APR1400

Feedback on Advanced Response to RAI 255-8285, Question 03.08.05-16, Part c.3

Prepared July 25, 2016

Figure 1 The schematic figure related with horizontal displacement

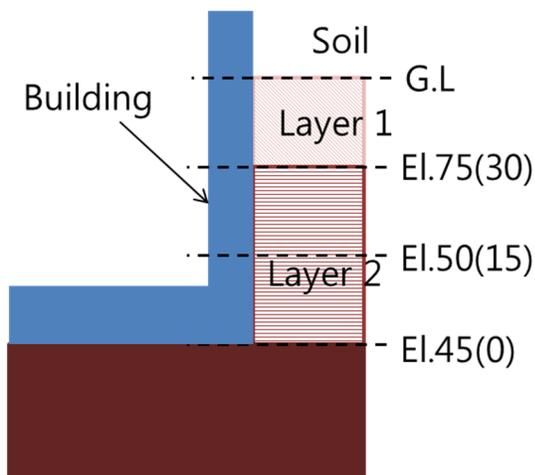
(1) The figure provided presents the horizontal displacement as a function of depth due to a horizontal unit pressure load applied at the surface. Explain why the lateral displacement between a height of 15 and 30 (the units for height are not shown) is constant rather than varying as a function of depth. Also identify the units of displacement and the units of the height shown in the figure.

The foundation media model used for horizontal displacement was consisted of 3 solid FE elements above 45ft elevation (bottom of NI common basemat) as shown in Figure 1. The graph in RAI 255-8285 Question 03.08.05-16 is made by displacement at each node and simplified. Also, as shown Figure 1 and Table 2-3 from technical report, APR1400-E-S-NR-14006-P, Rev1, the site properties at El. 75ft is changed to second layer properties. Due to above-explanation, the height of 15 and 30 seems to be constant.

In the graph, the units of displacement and height are feet.
